Vicki Jones for QLDC – Summary of Evidence, 25 November 2016

Chapter 13 Wanaka Town Centre – Hearing Stream 08

**Appendix 2: Recommended Revised Height Precinct 1 (red) and
Height Precinct 2 (green) on Planning Map 21**

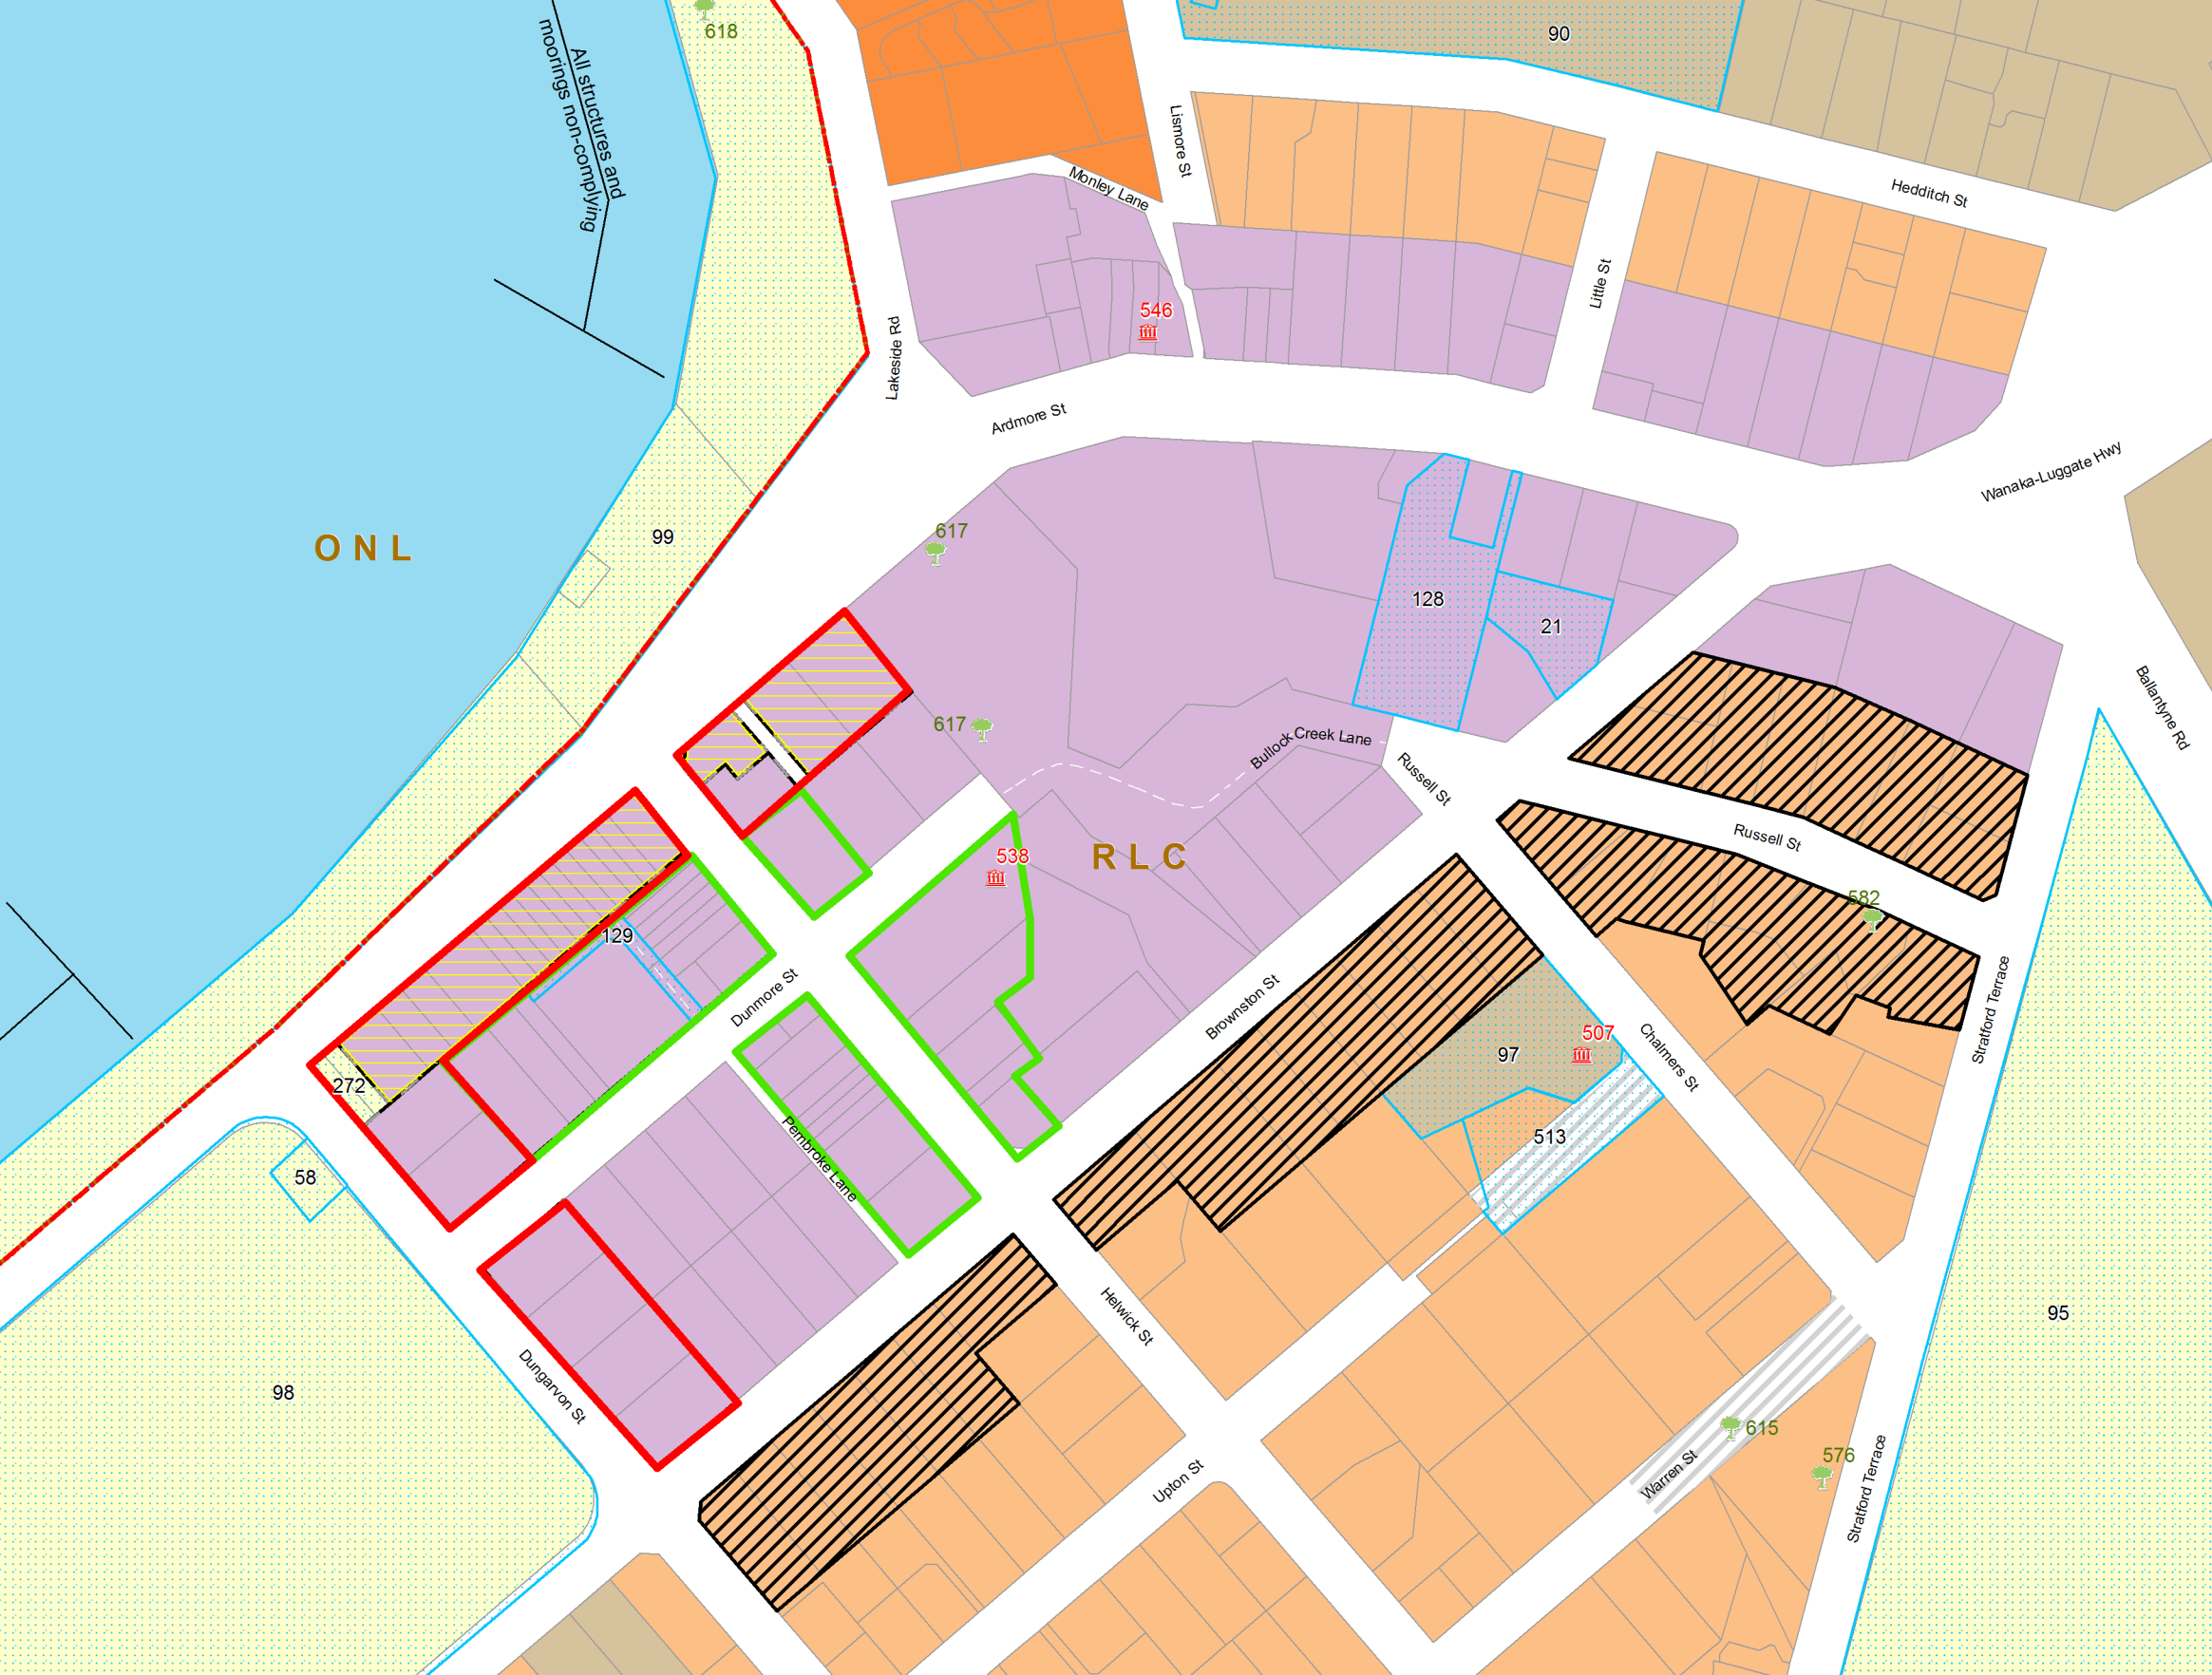
6. Having considered the evidence filed by Mr Ian Greaves and Ms Louise Wright on behalf of Gem Lake Limited (240), I also recommend creating a second height

precinct and applying this to those sites fronting Helwick Street south of the Dunmore Street intersection and also to those sites within the height precinct included in my s42A recommended chapter. The amendment is shown on the amended planning map attached as **Appendix 2**.

7. Rule 13.5.9 would also be amended to include Height Precinct 2, within which a height of 10 m to the eave and 12 m to the ridgeline and up to a maximum of 3 storeys would be enabled.
